FIELD SAFETY NOTICE / PRODUCT NOTIFICATION

Subject: Spine & Trauma 3D: Potentially Incorrect Automatic Image Registration for Siemens SOMATOM Definition AS CT Scanner

Product Reference: Navigation Software Spine & Trauma 3D 2.0 and 2.1

Brainlab Identifier: CAPA-20140520-000702

Figure 1: Schematic diagram of a potential virtual shift of CT image data set

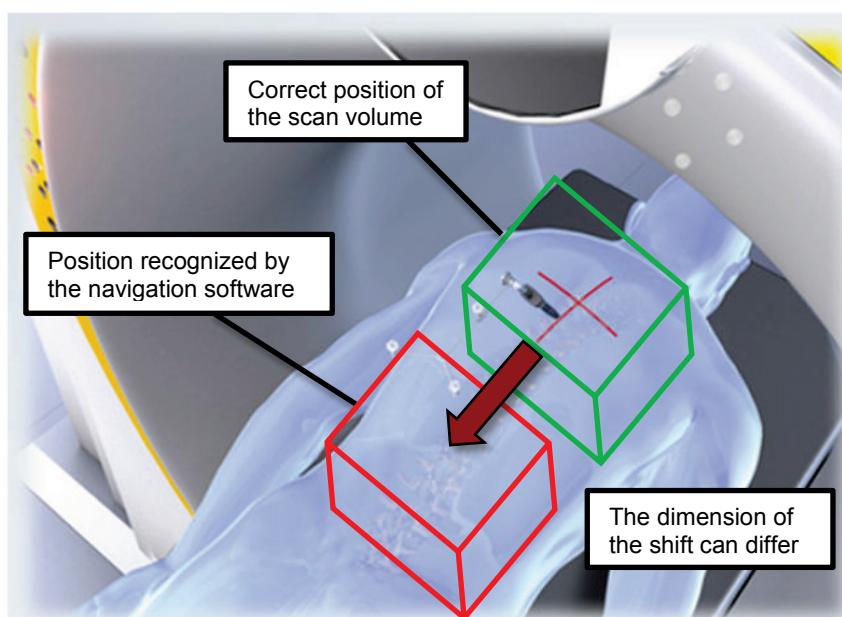
Due to a change in the corresponding Siemens data output, the information from the CT scanner cannot be correctly processed in the navigation software, when using:

- **Automatic Registration of iCT Data**, in combination with
- **Siemens SOMATOM Definition AS** CT scanner with Software Somaris SOM 7 (or higher), and
- **Automatic Gantry Communication** (available for Spine & Trauma 3D 2.0 and 2.1 only).

As a result, in the navigation software the CT image data set appears shifted in the scanner movement direction (patient head-feet direction). The scale of the shift can differ in each scan, varying from sub-millimeters to meters.

Brainlab will schedule a service visit for affected customers, to change the gantry communication from automatic to manual.

In the meantime, until Brainlab service has changed the gantry communication, **do not use Automatic Registration of iCT Data, in combination with Siemens SOMATOM Definition AS CT scanner** (with Software Somaris SOM 7 or higher), **and Automatic Gantry Communication** (available for Spine & Trauma 3D 2.0 and 2.1 only)

Figure 2: Brainlab Spine & Trauma 3D: Enter Gantry Position dialog

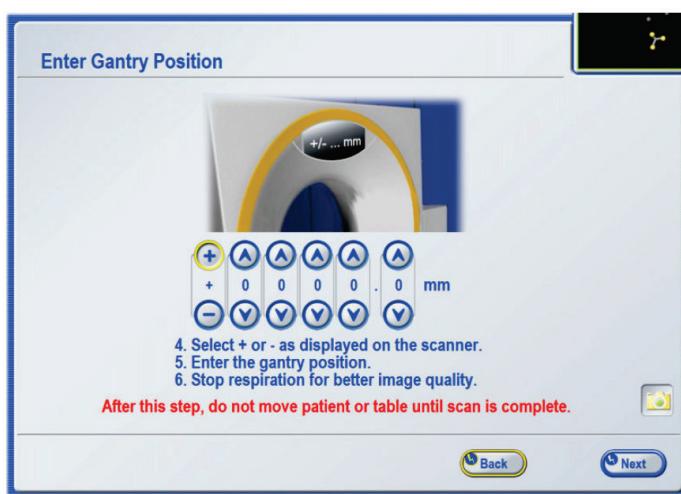
When using manual gantry communication, the software prompts you to enter additional information. Please follow the instructions on the screen accordingly (see figure 2) and refer to the descriptions in the Software User Guide, section Automatic Registration of iCT Data.
